Responses to comments from
Planning Departments, Lands Department, Agriculture, Fisheries
and Conservation Department and Highways Department

Comments from Planning Department dated 22.12.2025

**S. 12A Application for
Rezoning Application from “AGR” and “GB” to “OU (Columbarium)”
Various Lots in D.D. 41
and Adjoining Government Land, Tong To, Sha Tau Kok, N.T.**

**DLON Plan1
(P 17106)**

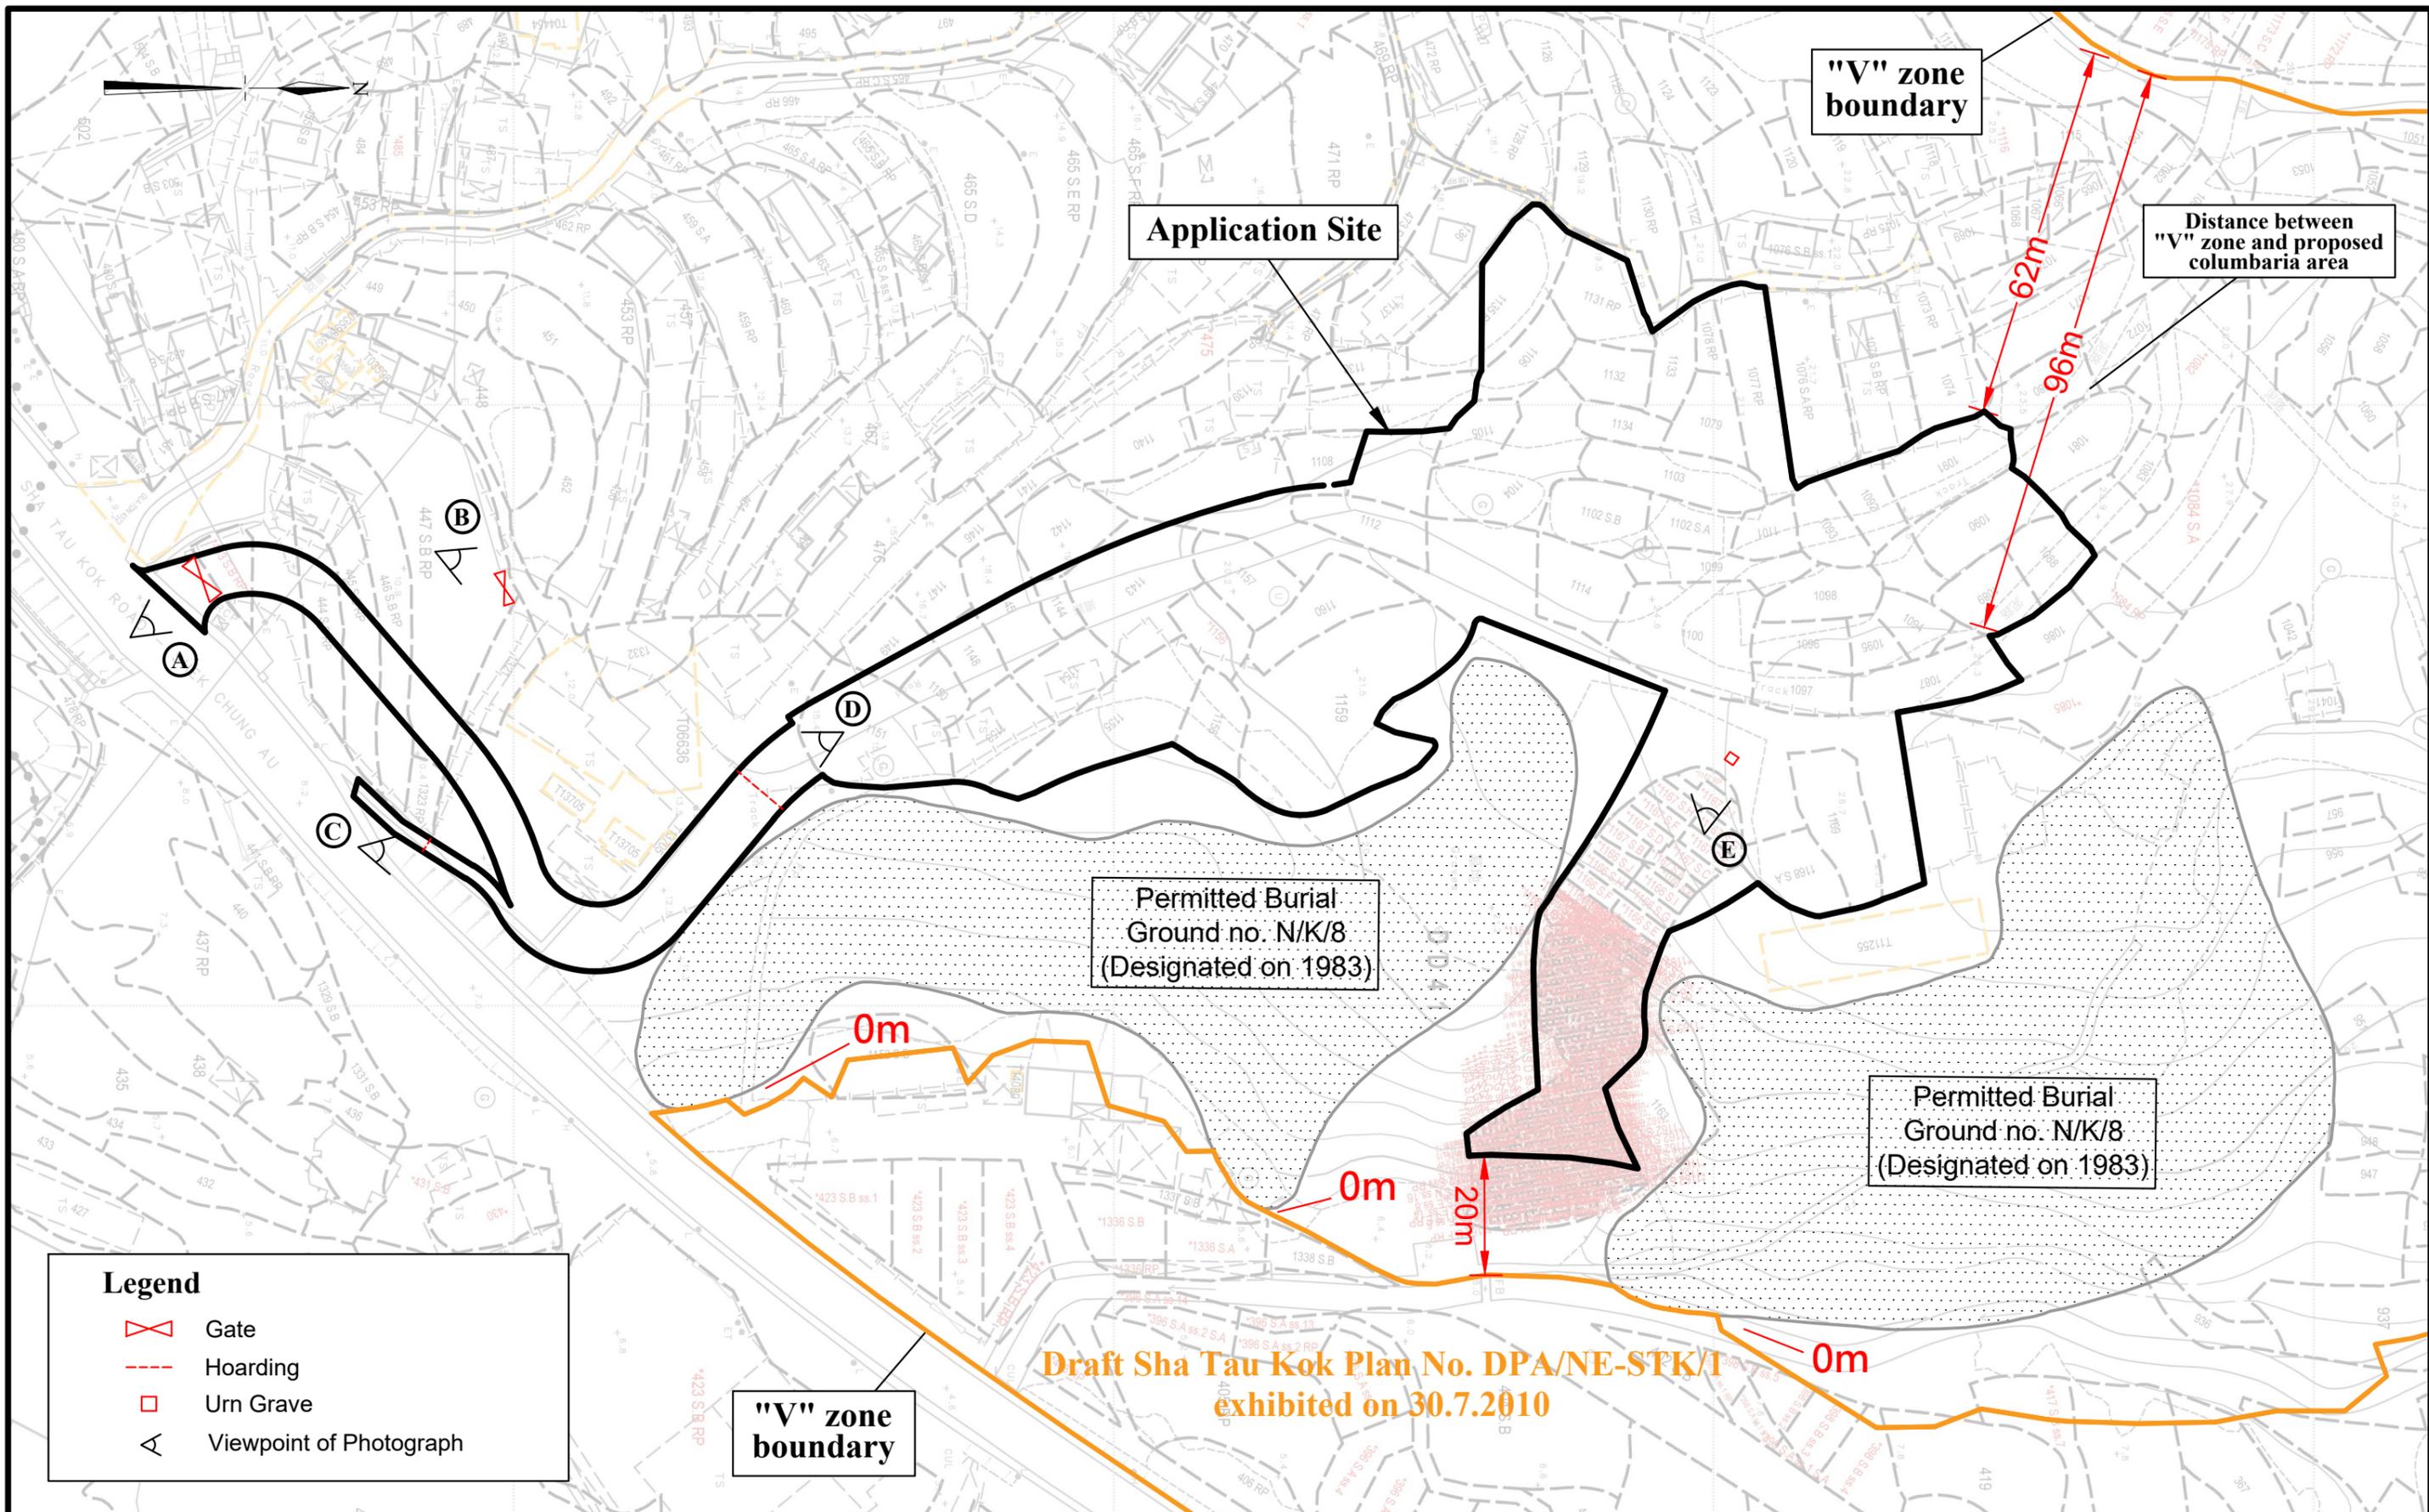
13.	According to the application, GL of about 2,815m ² is included in the application site. The area and extent of the affected Government land has not yet been verified at this stage. Having said that, it is noted some areas of the affected GL, particularly the portions forming the proposed access roads to the proposed development, may not be incapable of reasonable separate alienation or development. Besides, there is / are grave(s) / urn(s) on the	<p>The applicant had a joint visit with the staff of DLO/N. The result of the visit was that there was no urn nor graves on the affected GL. One empty structure was found on GL. The urn has been removed.</p> <p>The owner of this empty structure Mr. 蘇志華 (So) was identified. District Office/North (DO/N) has informed So to remove the empty structure. So informed</p>

Comments	Responses
<u>Inclusion of Government Land (GL)</u>	
<p>For point 14 of the Response-to-comment to LandsD (“the R-to-C”), it was observed during our re-inspection on 12.1.2026 that an empty urn shelter bearing number “NDO-2780-99” was found on GL within the application site. You may seek DO(N)’s comment in this regard. In particular, (i) whether approval has been given by DO(N) for the burial thereat; (ii) presumably there is no human remains buried underground. You may further clarify with DO(N); (iii) whether there is any record of urn removal according to DO(N)’s record, and (iv) whether DO(N) has any comment on the proposed removal and the removal arrangement of the urn shelter.</p> <p>The applicant focused on the arrangement of the urn shelter but had not responded to our previous comment (paragraph 5 of our previous memo of 7.1.2026) that “...it is noted some areas of the affected GL, particularly the portions forming the proposed access roads to the proposed development, may not be incapable of reasonable separate alienation or development... the GL included in the application site may not be available/able to be granted for the subject proposal (if applied).”, which remains valid.</p>	<p>The empty urn shelter has been removed. Please find attached letter from the owner of the empty urn shelter and four photographs for details.</p>

The applicant had a phone conversation with Senior Land Executive DLO/N Mr. CHOW Wai Choi on 8.1.2026. As a result of the discussion, the applicant removed the structures on G.L. and agreed to handle the empty structure according to the discussion:

- a. the gate A near the entrance of the site (Photo A and Marked “A” on Plan) has been removed,
- b. the gate B near Lot 447 S.B RP in D.D. 41 (Photo B and Marked “B” on Plan) has been removed,
- c. the gate C near Lot 1323 RP in D.D. 41 (Photo C and Marked “C” on Plan) has been removed,
- d. hoarding near Lot 1151 in D.D. 41 (Photo D and Marked “D” on Plan) has been removed, and
- e. It is agreed that the small empty structure on GL of which the owner undertakes to remove after the Ching Ming Festival 2026 (Photo E and Marked “E” on Plan).

The structures on Government Land have been removed, and the remaining one will be removed after the Ching Ming Festival 2026. For your information, please.

**Plan 2a
(P 17106)**

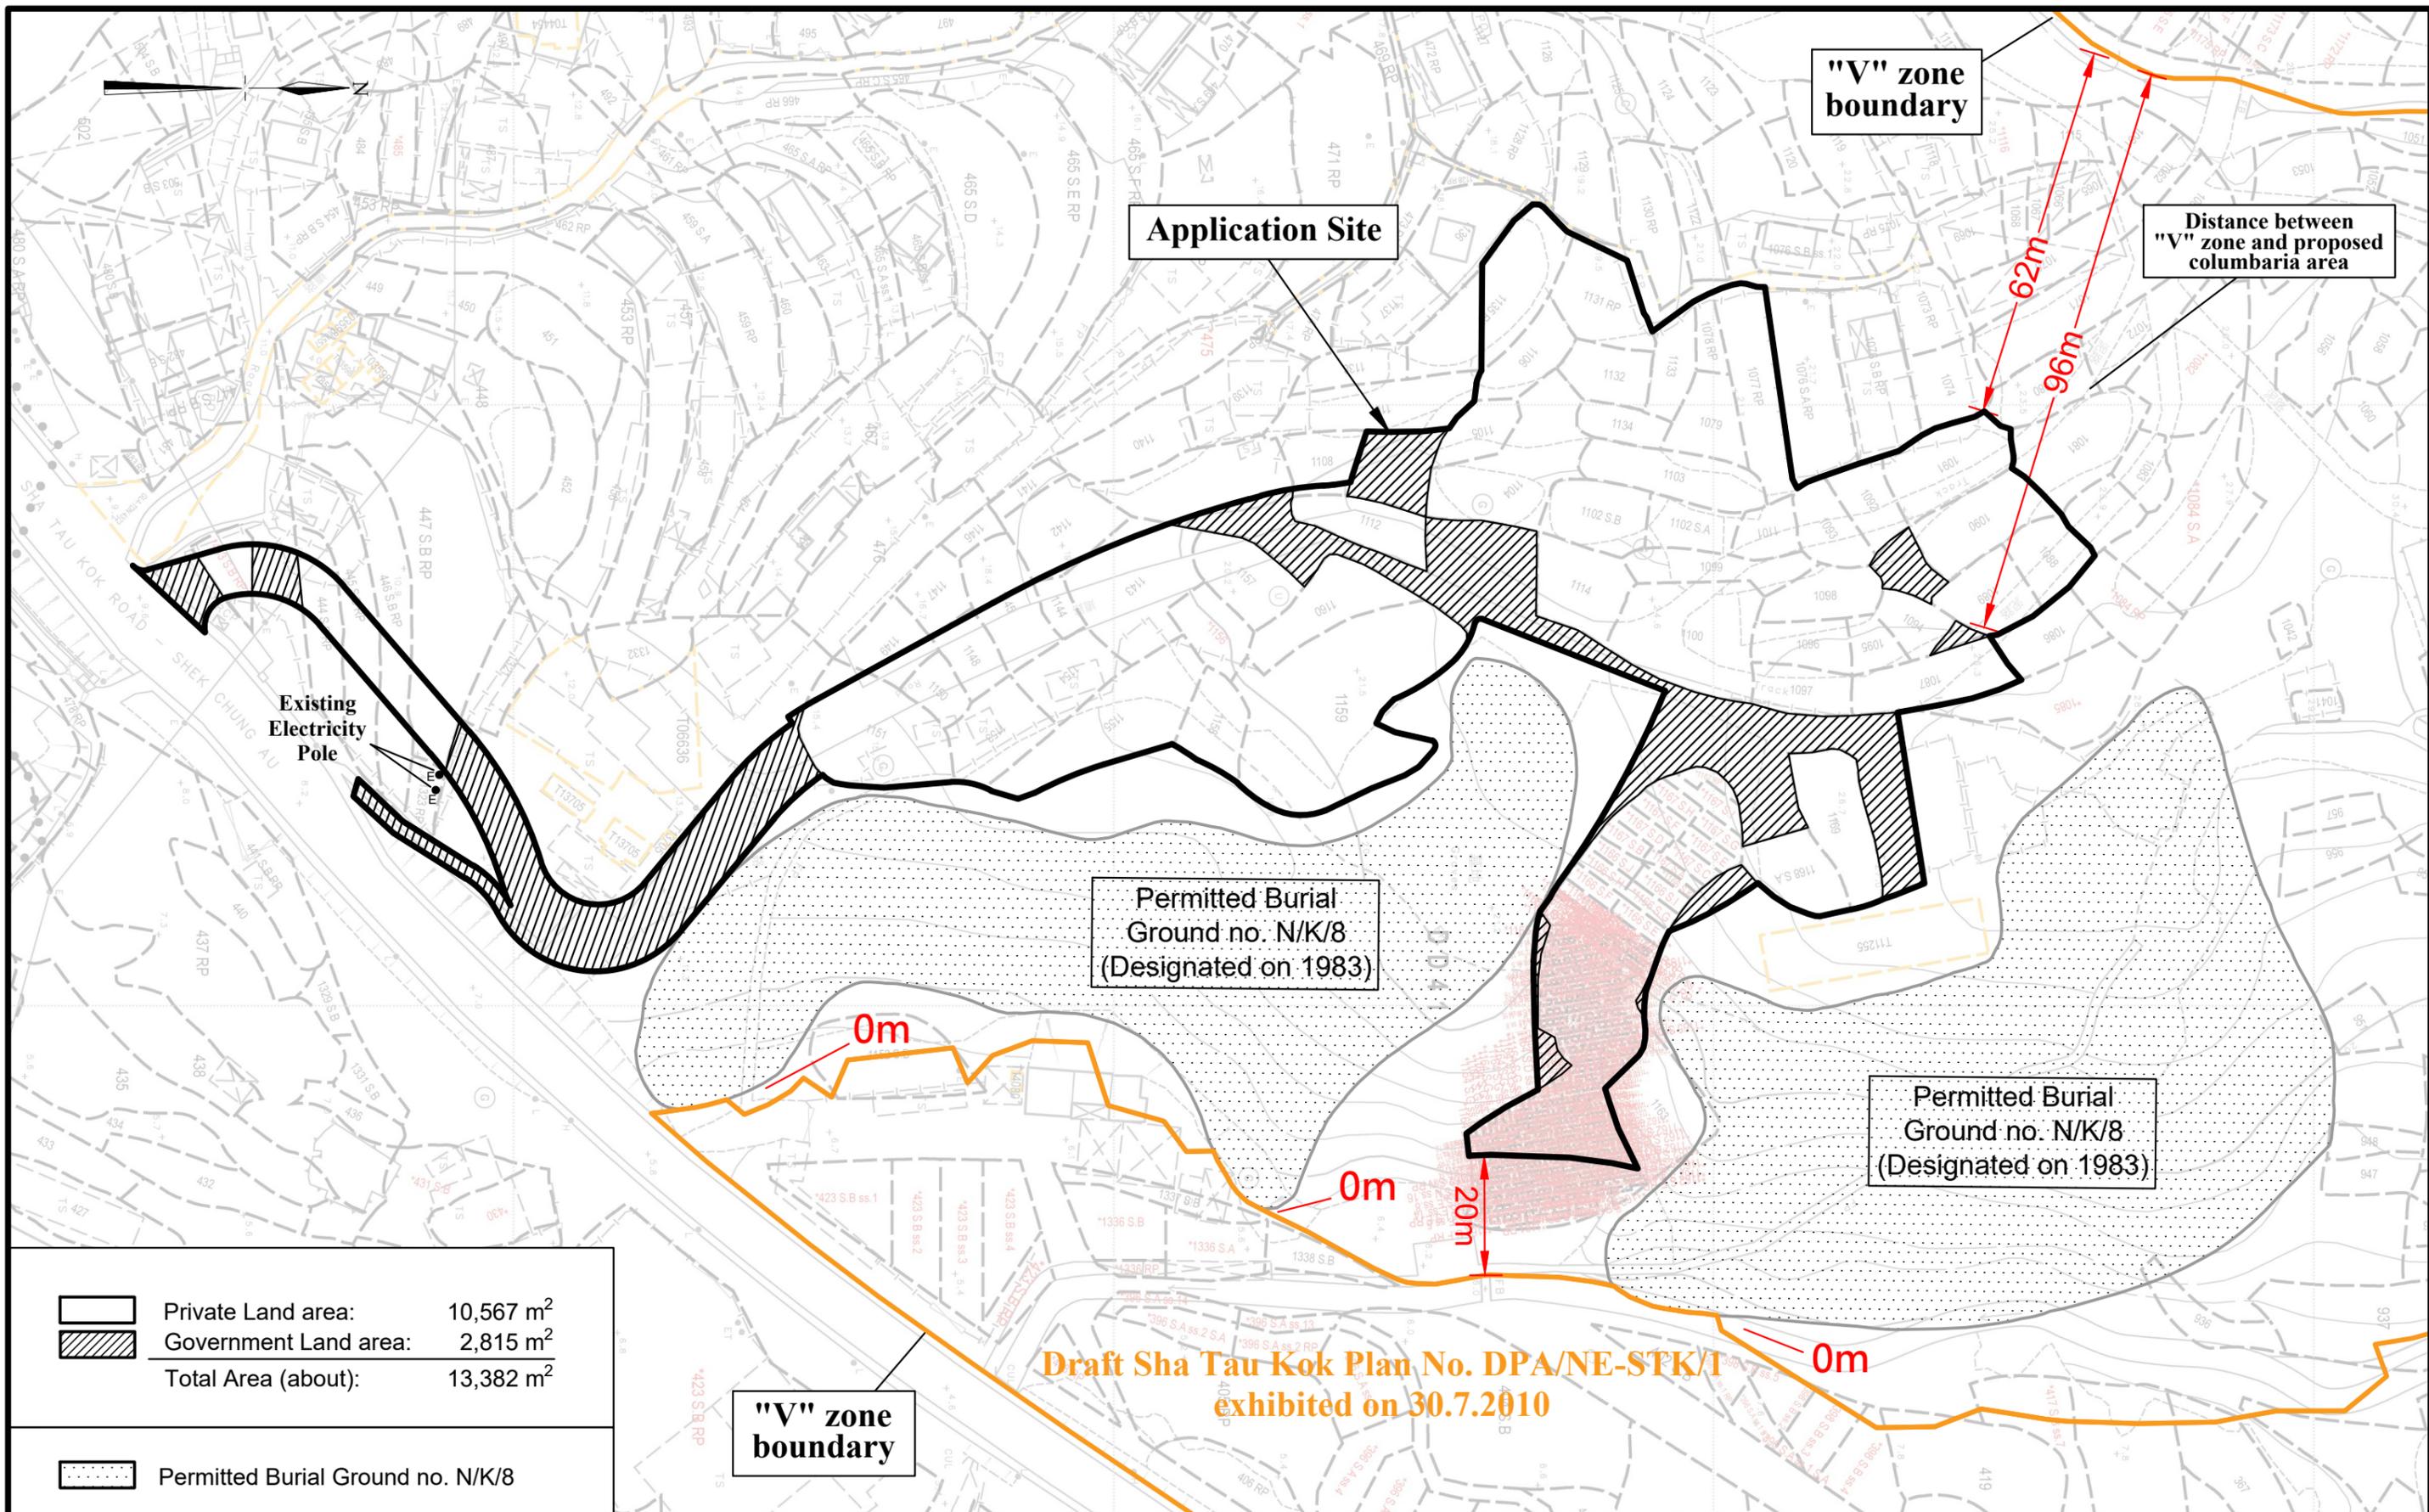
<u>Boundary of the Application Site</u>	
<p>Comments given in paragraph 6 of our previous memo of 7.1.2026 is still valid.</p>	<p>The applicant is aware that the boundary of the application site may not be in a regular shape.</p>
<u>Proposed Access Roads</u>	
<p>In point 16 of the R-to-C, the applicant alleged that a short direct access from Sha Tau Kok Road to the columbarium area would cross some GL and private structures. However, subject to HyD’s view on necessary slope modification works (for Slope No. 3/NE-C/C45), the applicant may in fact provide a short direct access to Sha Tau Kok Road over GL. In any event, a diverted footpath from the proposed main road lacks strong justifications since no particular analysis of alternative options is seen. The applicant should therefore further review and justify the access road proposal.</p>	<p>The proposed footpath is diverted from the main road to avoid an existing electricity pole. Please refer to updated Lot Index Plan (Plan 2a) and attached photograph showing the existing electricity pole.</p>

Existing electricity pole on
Lot 1323 RP in D.D. 41
